# **AN ASSESSMENT OF THE POTENTIAL EFFECTS OF THE DAYS COVE RUBBLE LANDFILL ON AQUATIC RESOURCES**

Prepared By  
Richard D. Klein  
Community & Environmental Defense Services  
8100 Greenspring Valley Road  
Owings Mills, Maryland 21117  
410-654-3021

On Behalf of  
Millington Quality of Life Preservation Coalition  
102 Archer Landing Road  
Millington, Maryland 21651  
410-928-3406

September 28, 1999

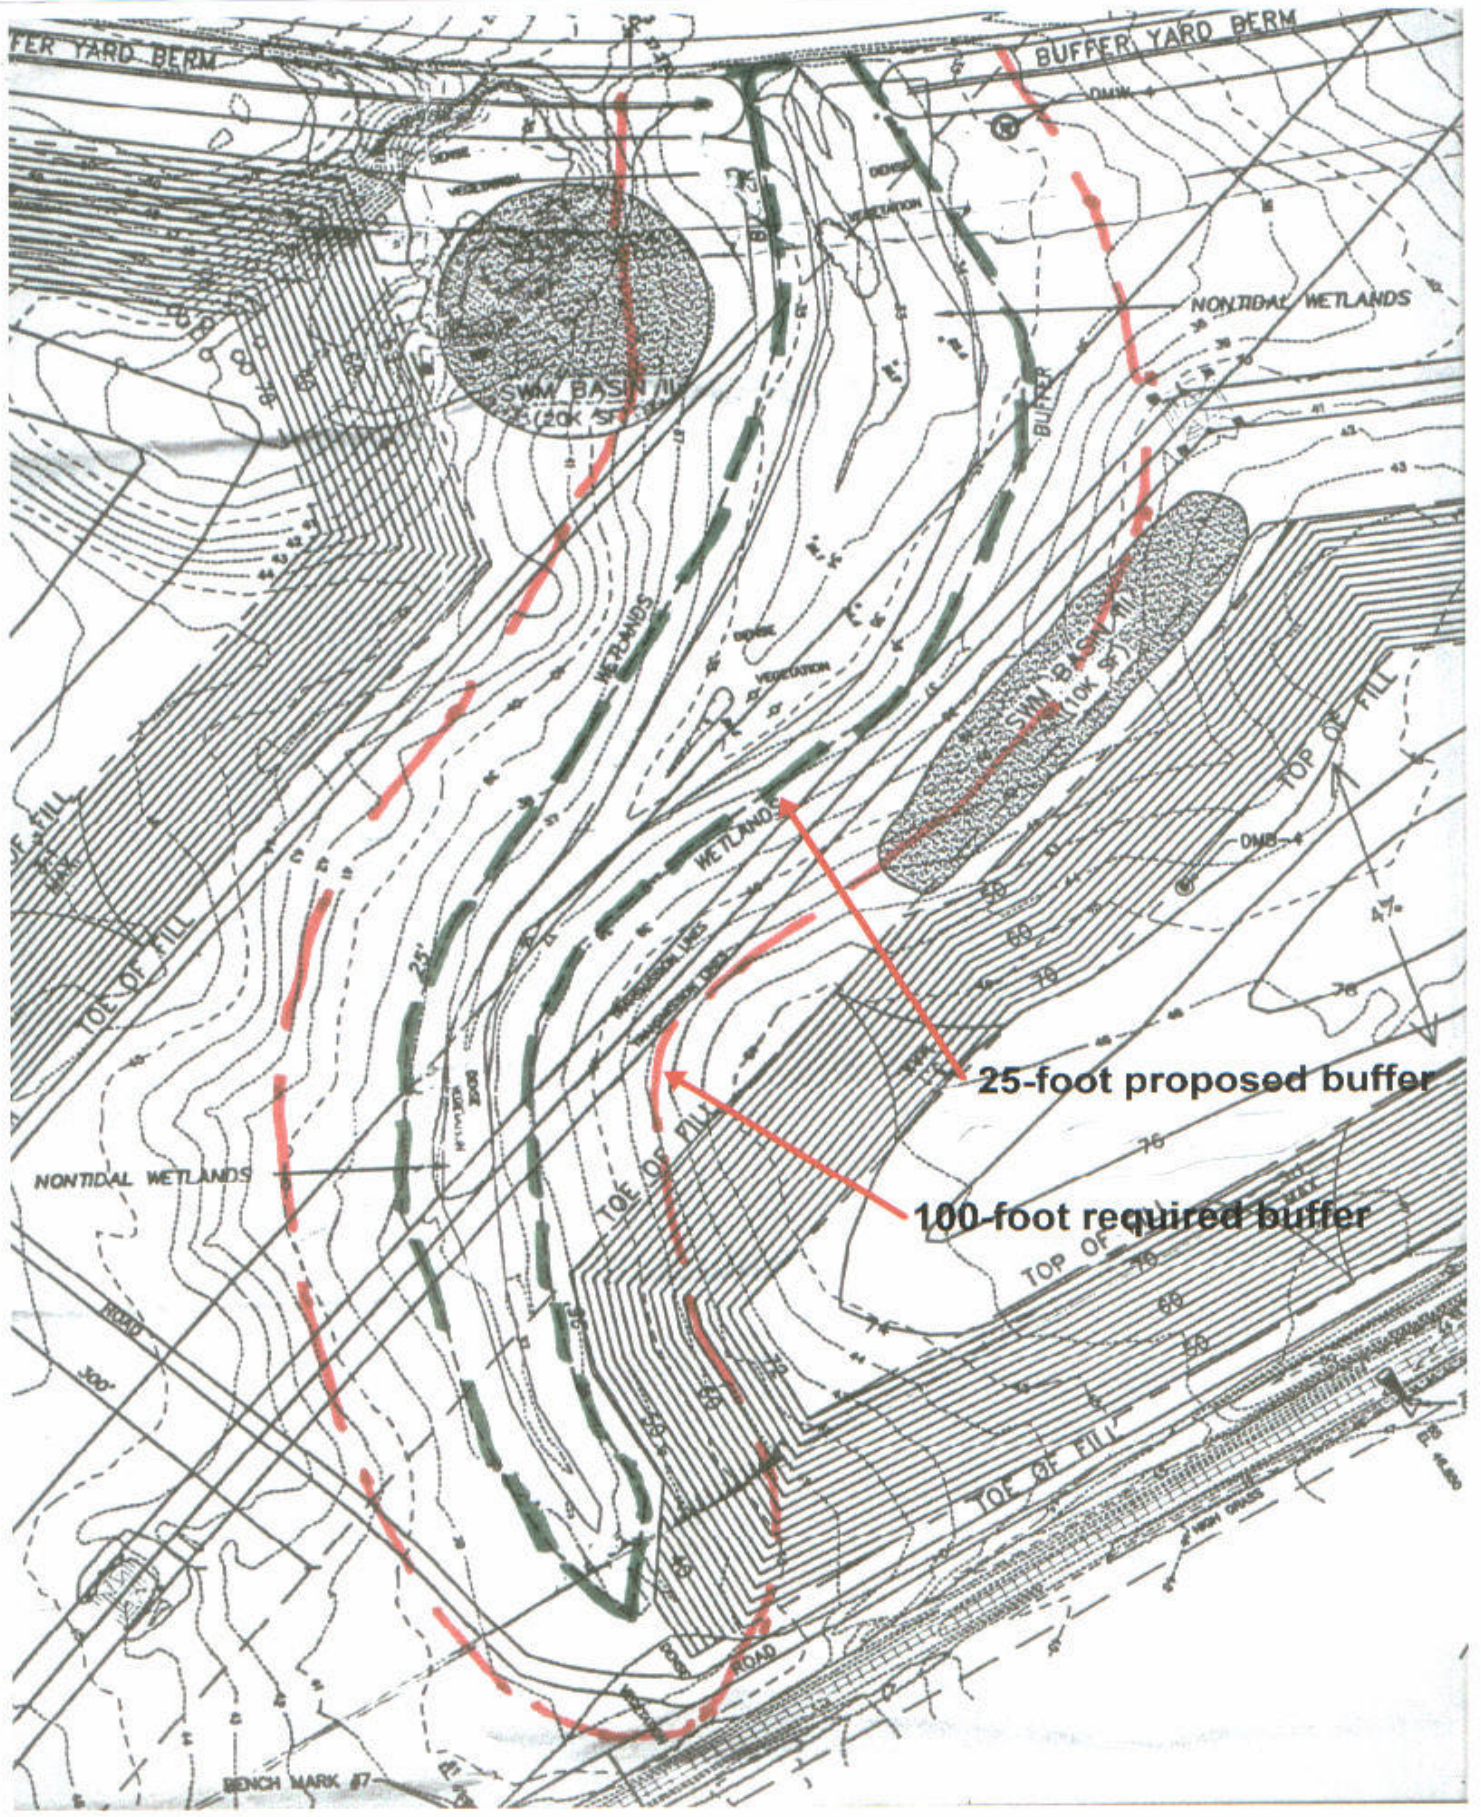
Maryland Department of the Environment regulations require a 25-foot buffer for most nontidal wetlands. However, an expanded buffer of 100-feet is required for Nontidal Wetlands of Special State Concern (COMAR 26.23.01.04A(1)). As stated above, the Unicorn Millpond Nontidal Wetland of Special State Concern extends into the rubble landfill site.

The site plan for the rubble landfill only shows a 25-foot buffer along the Nontidal Wetland of Special State Concern. On the next page of this report an excerpt is provided from the applicant's site plan. On the excerpt the applicant's proposed 25-foot wetland buffer is highlighted with green. The required 100-foot expanded buffer is highlighted with red. Note that the applicant has proposed intruding upon the 100-foot expanded buffer with a portion of the landfill, two stormwater management basins, two buffer yard berms, and a road. These proposed activities are clearly in conflict with Maryland Department of the Environment regulations and would pose a serious threat to the health of the wetland.

25-foot proposed buffer

100-foot required buffer

## Metals in Rubble Landfill Leachate

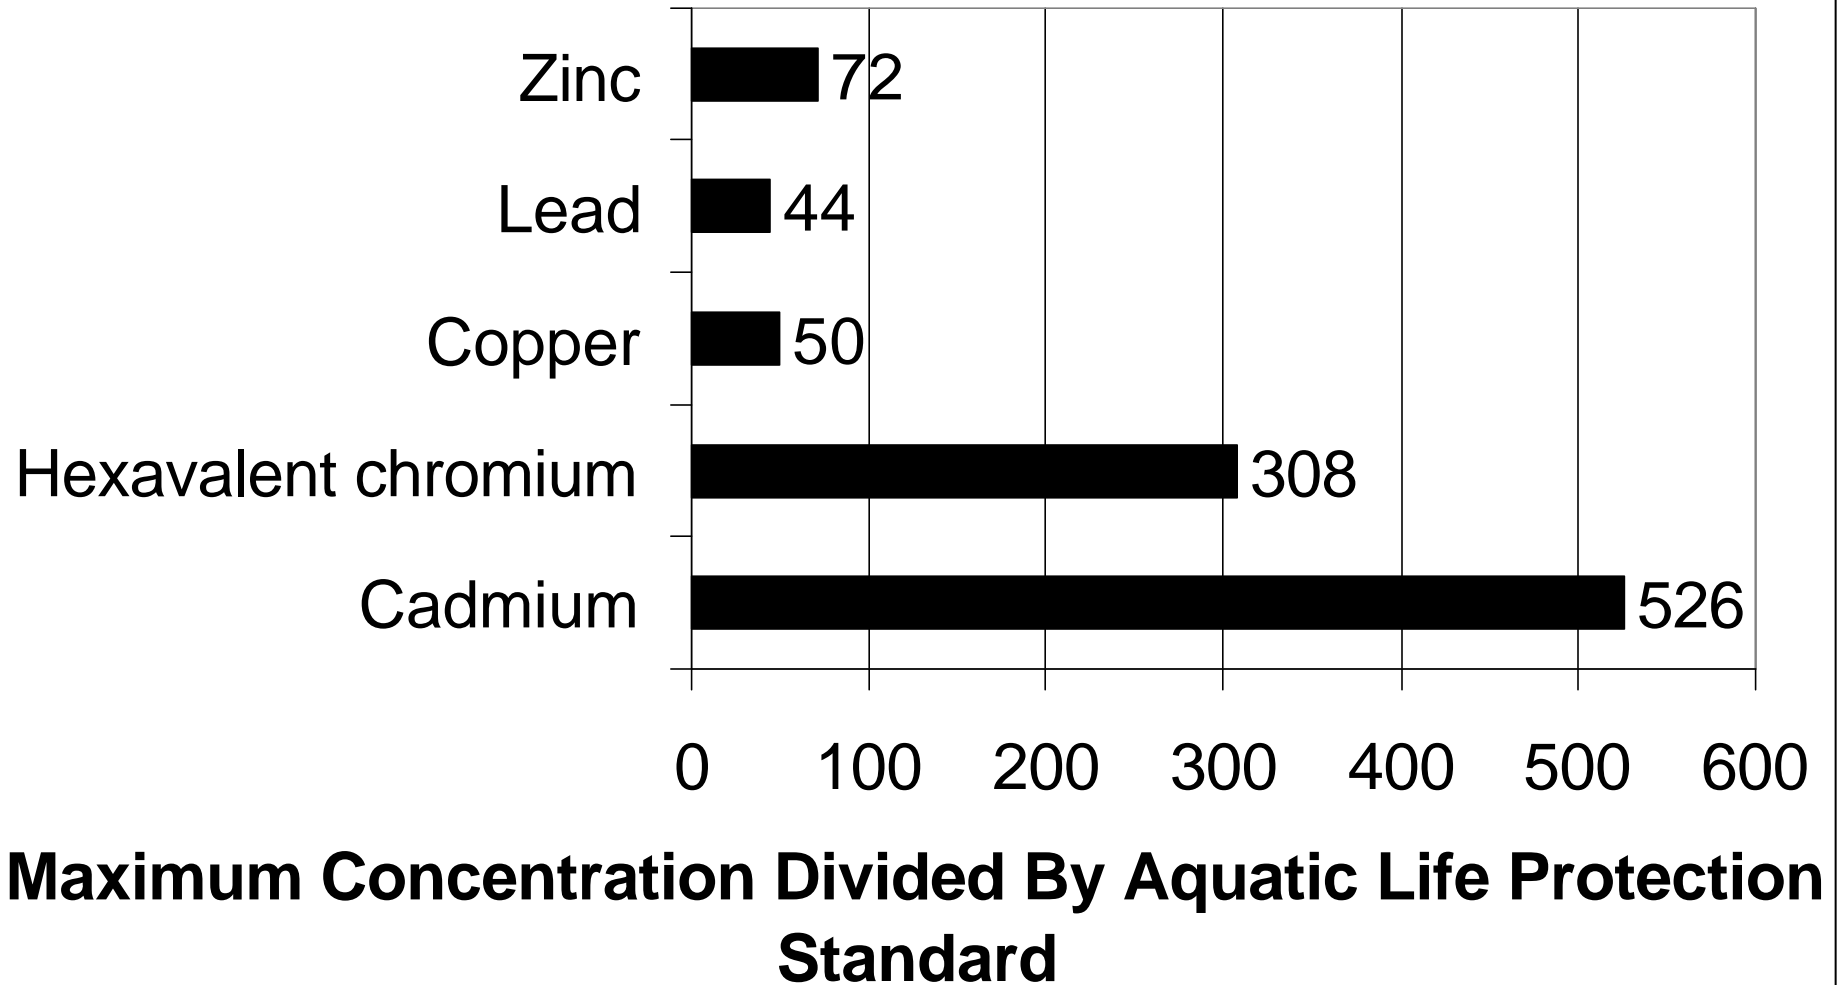
The graph following this page provides a visual comparison of the maximum metal concentrations and the aquatic life protection criteria. The data presented in the graph shows that when leachate is released from the Days Cove rubble landfill, a severe threat will be posed to all of the sensitive aquatic resources associated with the site - the brown trout and other fisheries of Unicorn Branch, the rare and endangered plants in Unicorn Millpond, the river herring and other fisheries of the Millpond, and the Nontidal Wetland of Special State Concern located on the site.

# Days Cove Landfill Stormwater Impacts

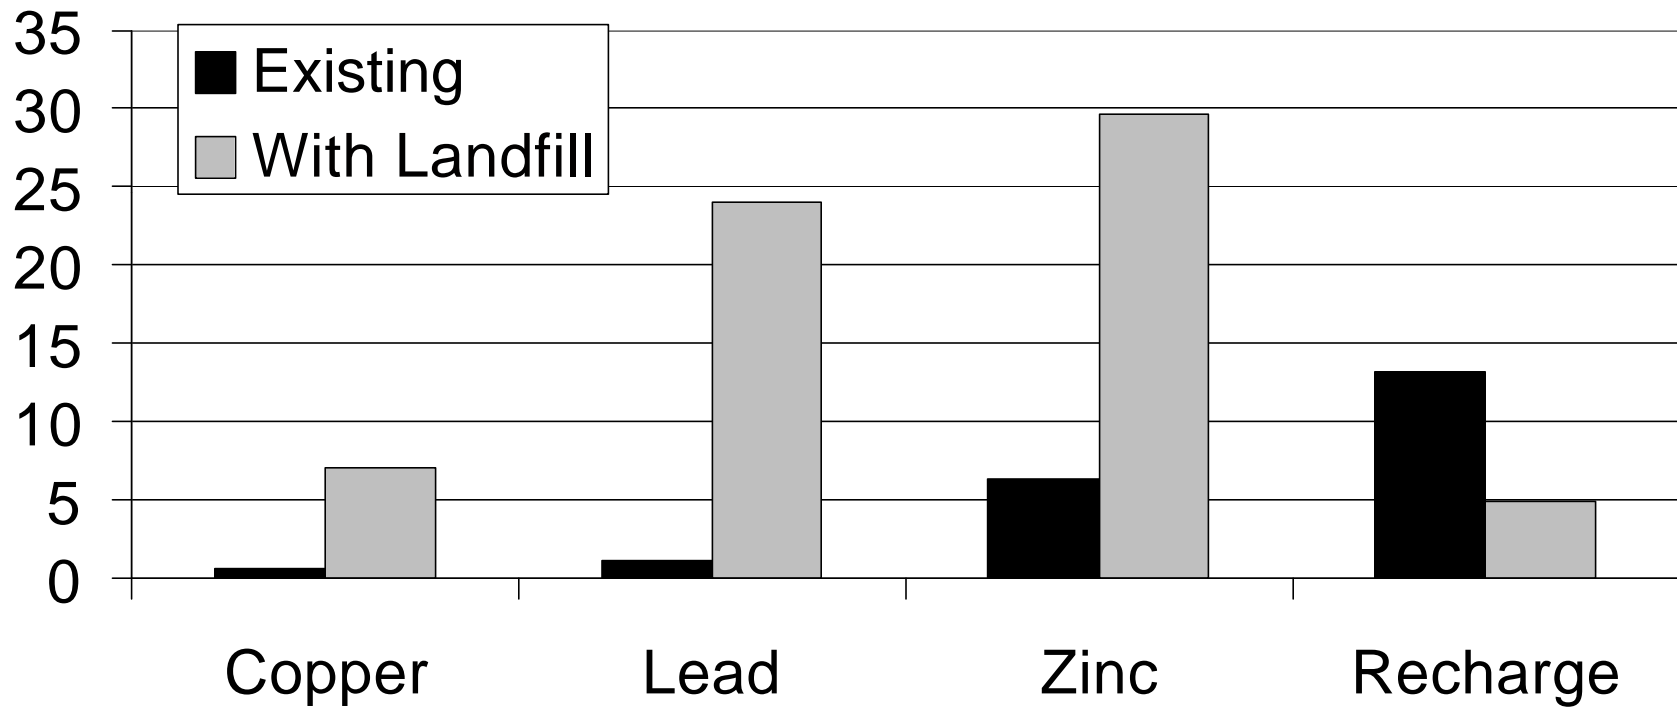
Table 3 shows that on average about 228,000 gallons of recharge occurs on each acre of land in eastern Queen Anne's County. Recharge is eliminated when the land surface is covered by asphalt, buildings, concrete, and other impervious surfaces. A rubble landfill cap and liner are also impervious materials.

Table 3 shows that presently about 13 million gallons of recharge occur on the landfill site each year. Once the landfill is constructed recharge will plummet to just 5 million gallons per year. This will greatly diminish the amount of groundwater entering the Nontidal Wetland of Special State Concern located on the site. This alone would have a devastating impact upon the health of this wetland ecosystem. Combined with metals entrained in leachate and stormwater discharges, it is highly unlikely this wetland will continue to function.
